Plan Review, Inspection, and Permit Fees

Application Number : **FMFW1808-0002**

Re: Campbell University Street Fair
Application Number: FMFW1808-0002

Application for Plan Review

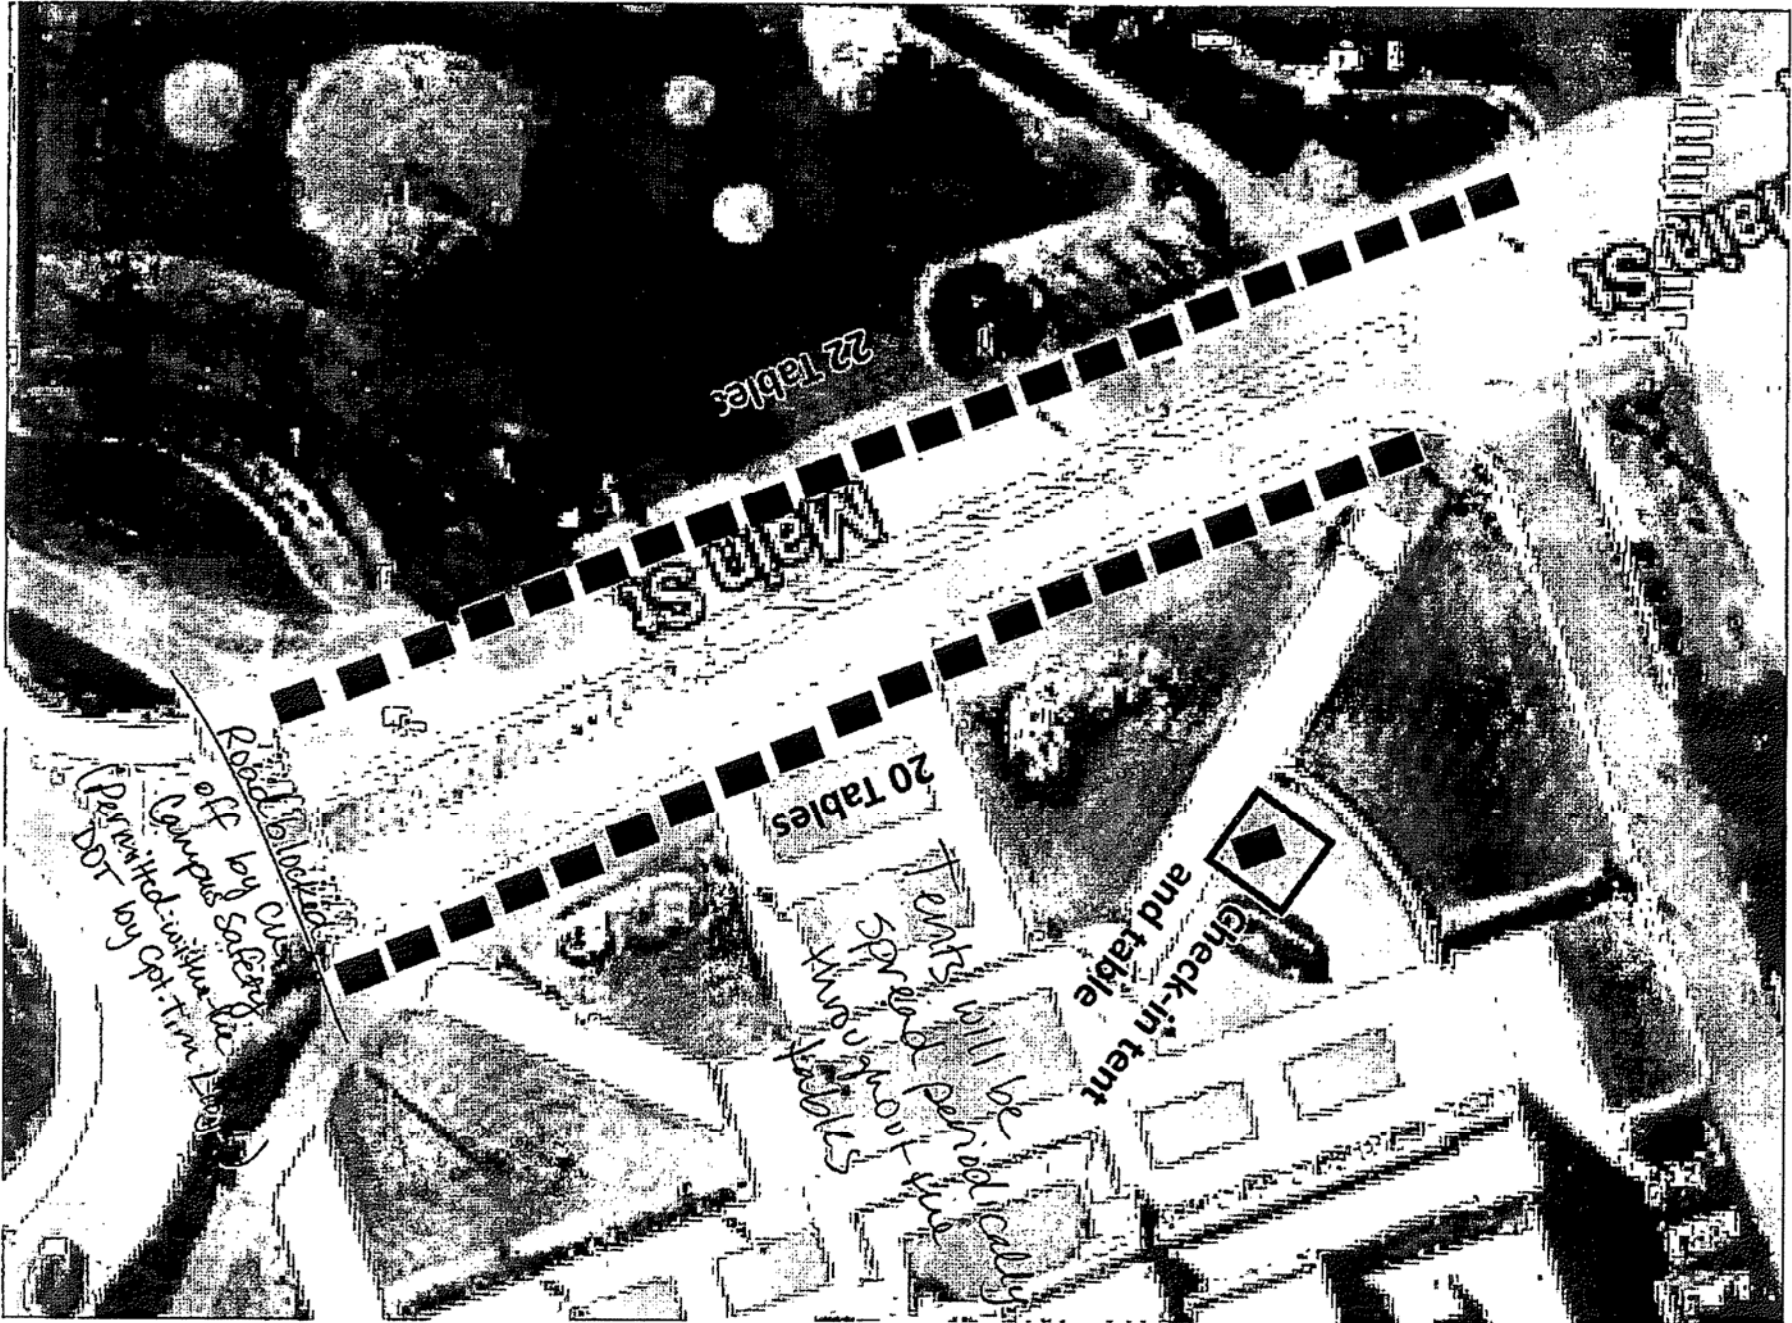
- **Permits**
 - A permit will be issued for the special assembly that will include the event as a whole.
 - A permit may be issued for other tent areas if the individual tent exceeds 700 ft² or the aggregate area of multiple canopies placed side by side without a fire break clearance of 12'
- **Fire Extinguishers**
 - Portable fire extinguishers shall be provided within a 30-foot (9144 mm) travel distance of commercial-type cooking equipment. Cooking equipment involving vegetable or animal oils and fats shall be protected by a Class K rated portable extinguisher.
 - 2A-10B:C fire extinguisher shall be placed at tents/canopies with a travel distance not to exceed 100' from any fire extinguisher
- **2411.6 Outdoor cooking.**
 - Outdoor cooking that produces sparks or grease-laden vapors shall not be performed within 20 feet (6096 mm) from a tent, air-supported, air-

inflated or tensioned membrane structure, temporary membrane structure or canopy.

- **2415 Generators**
 - Generators and other internal combustion power sources shall be separated from tents, air-supported, air-inflated or tensioned membrane structures, temporary membrane structures or canopies by a minimum of 20 feet (6096 mm) and shall be isolated from contact with the public by fencing, enclosure or other approved means.

- **2413.3 Refueling.**
 - Refueling shall be performed in an approved location not less than 20 feet (6096 mm) from tents, air-supported, air-inflated or tensioned membrane structures, temporary membrane structures or canopies.

- **Permits**
 - Final inspection will be conducted that day of the event and the permit will be issued.
- **2406.4 Combustible materials.**
 - Hay, straw, shavings or similar combustible materials shall not be located within any tent or air-supported structure containing an assembly occupancy, except the materials necessary for the daily feeding and care of animals. Sawdust and shavings utilized for a public performance or exhibit shall not be prohibited provided the sawdust and shavings are kept damp. Combustible materials shall not be permitted under stands or seats at any time. The areas within and adjacent to the tent or air-supported structure, shall be maintained clear of all combustible materials or vegetation that could create a fire hazard within 20 feet (6096 mm) from the structure. Combustible trash shall be removed at least once a day from the structure during the period the structure is occupied by the public.
